**Subject: Re-Inspection Report
Robbins Field (20A)**

**Subject: Annual Inspection Report
Robbins Field (20A)**

**Annual Inspection Report
Robbins Field (20A)
Oneonta, Alabama**

Photo # 1 – Runway 05 Approach

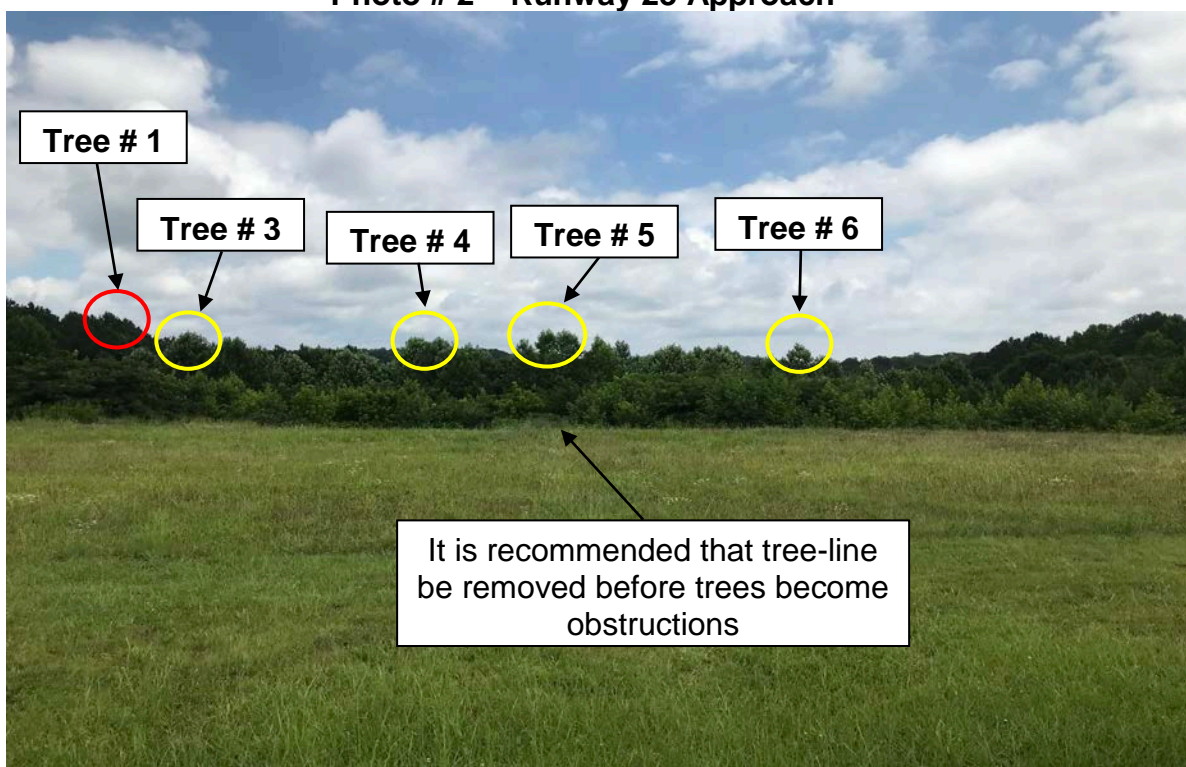
- Runway 05 – Brush labeled #1 obstructs the required 20:1 approach/departure path (See Photo #1 and Appendix 2).
- Runway 23 – Tree labeled #1 obstructs the required 20:1 approach/departure path. Trees labeled #3, #4, #5, and #6 will be obstructions soon if not removed (See Photo #2 and Appendix 3).

- Remove all obstructions to the required 20:1 approach/departure paths.
